**Canmore Lodge Owners Comments on:**

**22/01109/FUL**

**Demolition of Existing House and Outbuildings and Construction of Replacement House and  
Garage - High Ridge Top Street Askham Newark Nottinghamshire NG22 0RP**

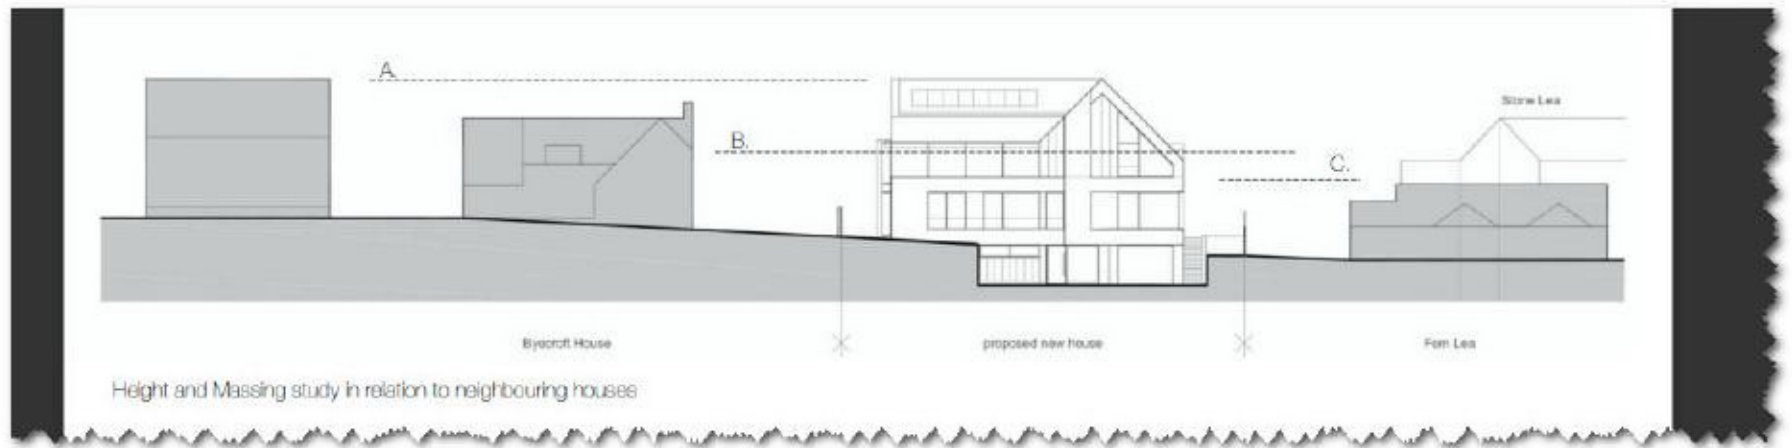
As can be seen from the above representation, the building will not sit comfortably with its neighbours with it being considerably larger and higher. The building replaces a single story dwelling with a 3 storey dwelling. The design refers to a 'Lower Ground floor', this terminology appears to be intentionally misleading - The term 'ground level', or 'ground floor', is used to refer to the level of a building that is at ground / street level, which in the case of this proposed building is the lowest level. The building does not compliment the surrounding buildings (see point 4).

Top Street drops in elevation towards the centre of the village (from west to east). A more appropriate and acceptable ridge height would be to align to the ridge height of Bycroft house less the natural fall of the road – which is exactly the Ridge height of the existing building at 58m above sea level.

1. The maximum development height of 'High Ridge' to be retained at 58m. This is the same height as Byecroft house, less the natural drop in the road.
2. The historically significant coach house to be retained and incorporated into the design.
3. For the main house to be redesigned to use local materials and local design inspirations which will complement the architectural styles within Askham. This should primarily focus on a reduction in glazing which will reduce the privacy impact on neighbours.
4. A detailed proposed site topography to be issued with any future applications.
5. For the developer to explain why the ecology study is redacted – specially in relation to bats
6. A commitment to undertake 'genuine' local engagement.
7. A revised Design and Access statement which corrects the numerous errors highlighted in these comments.
